Service Bulletin No: 57-012

Modification No: EC-11-0355

**WINGS - OUTER WING
REPLACEMENT OF THE LEFT AND RIGHT OUTBOARD AILERON BEARING-BRACKETS****1. Planning Information****A. Effectivity**

Removal / Installation of the Shim and Bracket
Figure 1

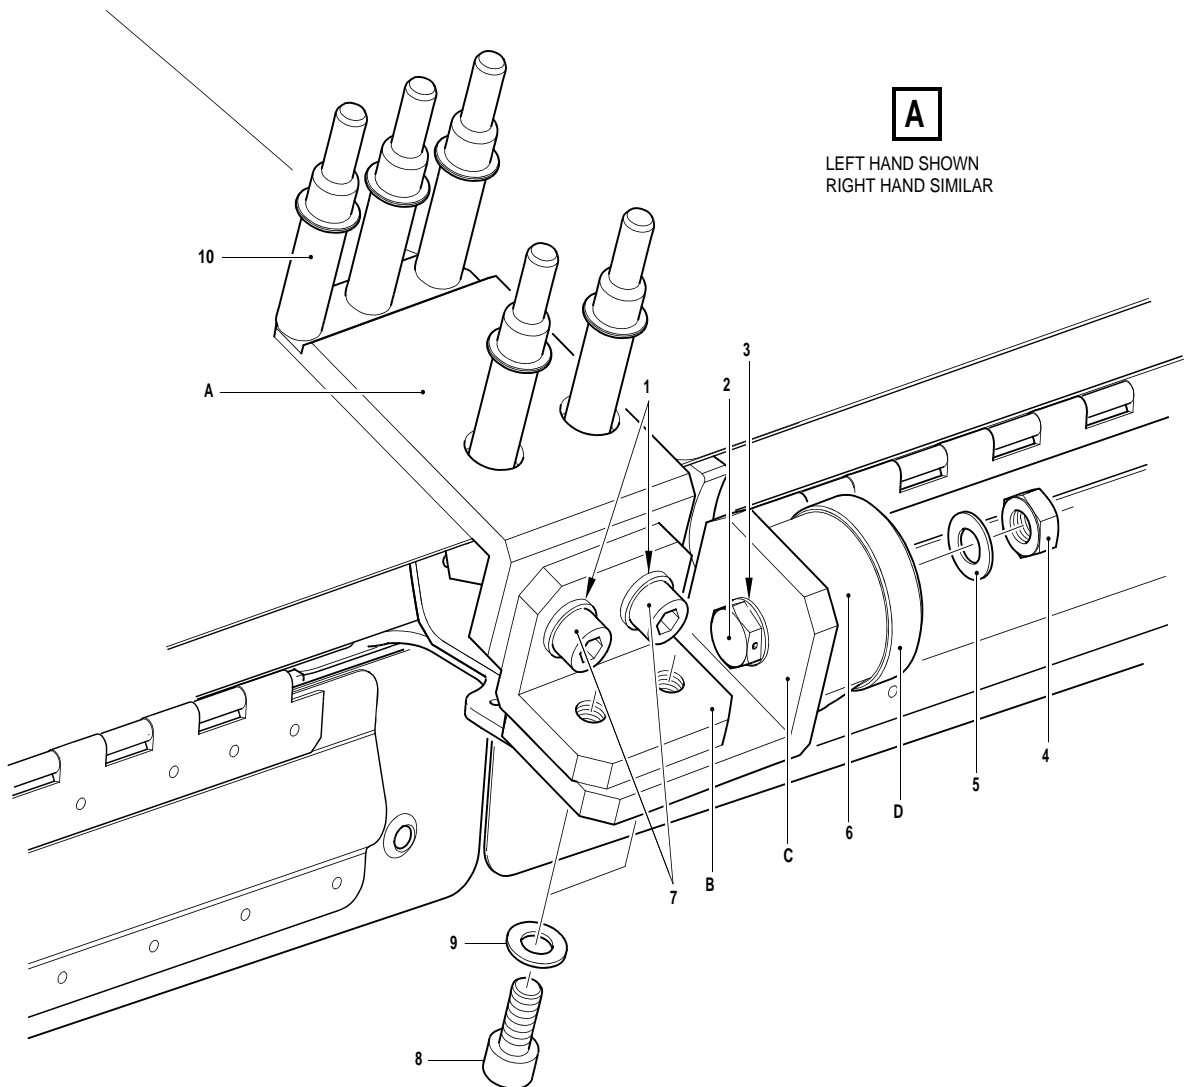
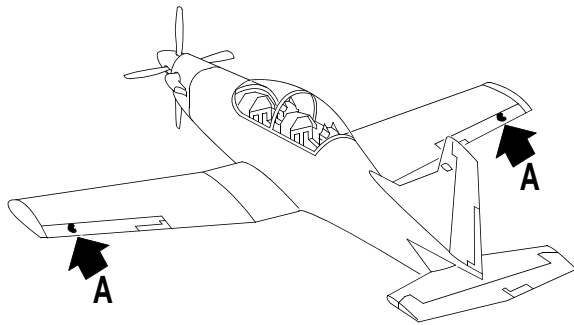
A Operator has found cracks in the aileron outboard bearing-bracket (bracket), P/N 557.22.09.281 (LH) and P/N 557.22.09.282 (RH) installed on some of his aircraft. If the rivets in the affected location come out, they could cause the aileron to become jammed or lost in flight.

It is possible for stress corrosion cracks to occur in the bracket, P/N 557.22.09.281 (LH) and P/N 557.22.09.282 (RH) made of aluminum alloy 2024-T351. These cracks would occur in the areas around the attachment fasteners.

Initially the material specification of the brackets, P/N 557.22.09.281 (LH) and P/N 557.22.09.282 (RH) was aluminum alloy 2024-T351. The material specification was subsequently changed to aluminum alloy 2124-T851 to reduce the risk of damage from stress corrosion. The part number was not changed when the new material specification was introduced.

This Service Bulletin is issued to replace the left and right brackets if they are not made from aluminum alloy 2124-T851.

- (1) If installed, make a note of the position of the shim (7) on the applicable bracket (5).
- (2) If installed, use the applicable sized drill and remove the three rivets (8) that attach the shim (7) to the applicable bracket (5).
- (3) Remove and keep the shim (7).
- (4) Remove the five rivets (3) from the top skin, outboard of the bracket (5).

- (1) Measure and record the height of the tail of the inboard forward rivet (10) that attaches the flange of the bracket (5) to the lower skin.
- (2) Remove the six rivets (9 and 10) that attach the flange of the bracket (5) to the lower skin.
- (3) Remove the eight rivets (2) that attach the flange of the bracket (5) to the upper skin.
- (4) Remove the rivet (1) from the upper skin.

- (6) Remove the remaining four inboard rivets (6) that attach the flange of the bracket (5) to the wing rear spar.
- (7) Remove the bracket (5).
- (8) Remove, and keep, the spherical bearing from the bracket (5).

Installation of the Placing Device
Figure 2

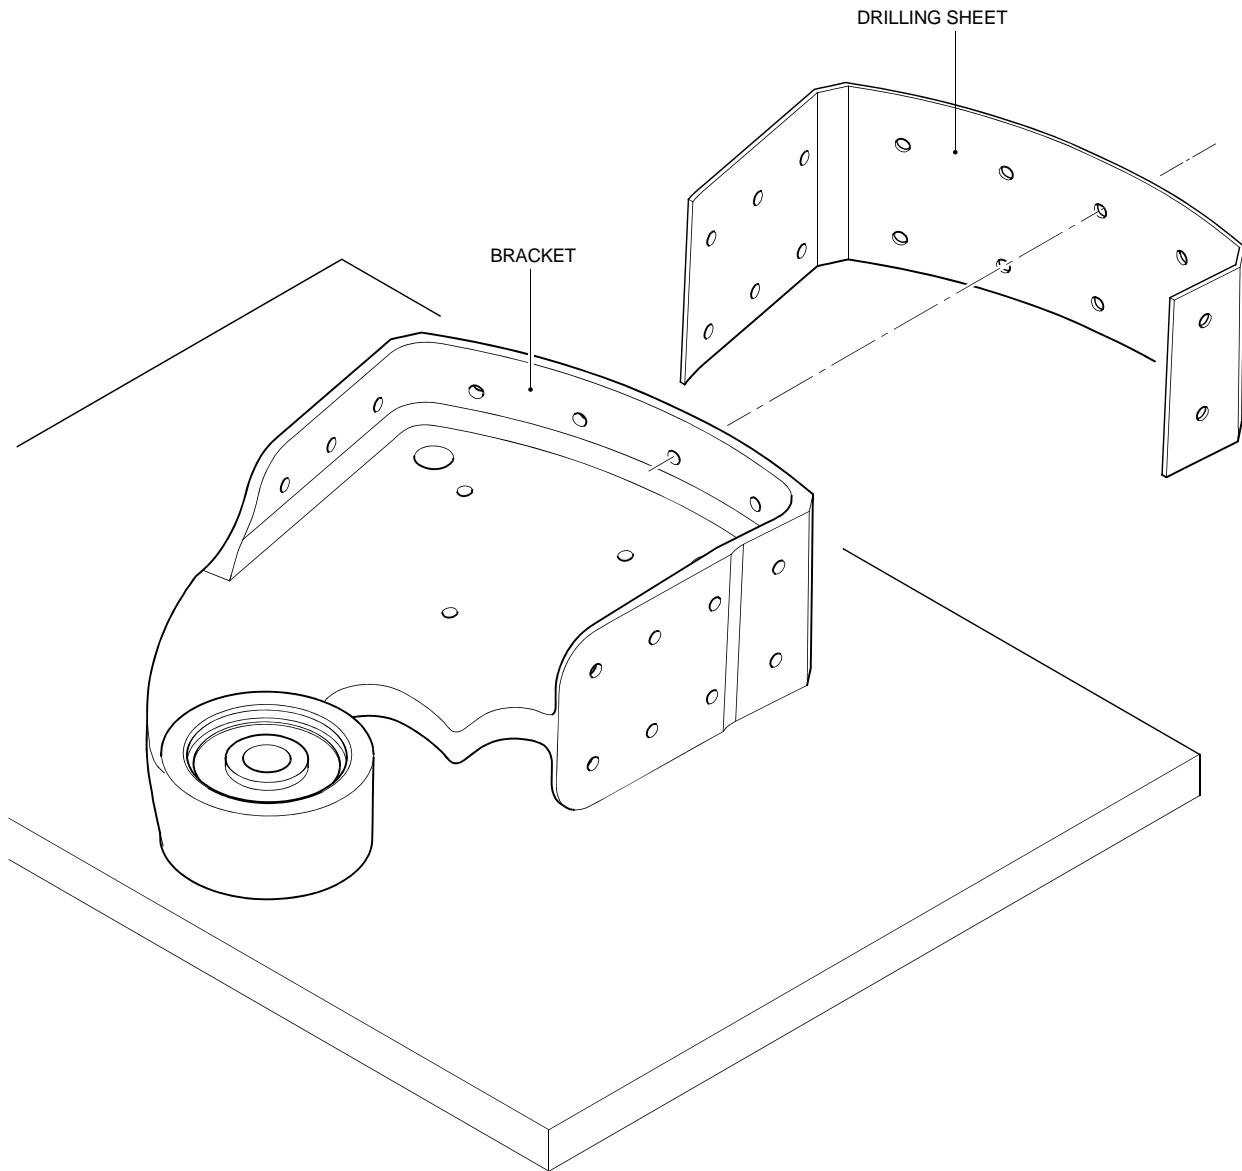
C. Install the Placing Device (Ref. Fig. 2)

- (1) Make sure there are no pencil marks on all parts of the placing device. If necessary, remove them with the absorbent paper (Material No. P02-031) made moist with the solvent (Material No. P01-010).
- (2) Put part A of the placing device in position on the top skin.
- (3) Hold in position with gripper pins, or equivalent, (10) through the five rivet holes in the top skin.

- (4) Put part C in position against the bearing of the bracket (6). Make sure the mating face of the bracket is smooth. If necessary, remove the paint.
- (5) Install the bolt (2), the washer (3), part D of the placing device, the washer (5) and the nut (4). Do not tighten the nut (4).
- (6) Put part B of the placing device in position against part A and part C of the placing device.
- (7) Install the two screws (7) and the washers (1).
- (8) Install the two screws (8) and the washers (9).
- (9) Make sure the gripper pins, or equivalent, (10), the screws (7 and 8) are tight.
- (10) Make sure that:
 - The bolt (2) and the spherical bearing can move freely
 - Part C of the placing device is in complete contact with the bracket (6).

- (11) Tighten the nut (4).
- (12) Draw lines around part A of the placing device to show its position on the wing top skin.
- (13) Draw lines around part B of the placing device to show its position against part A.
- (14) Draw lines around part B of the placing device to show its position against part C.
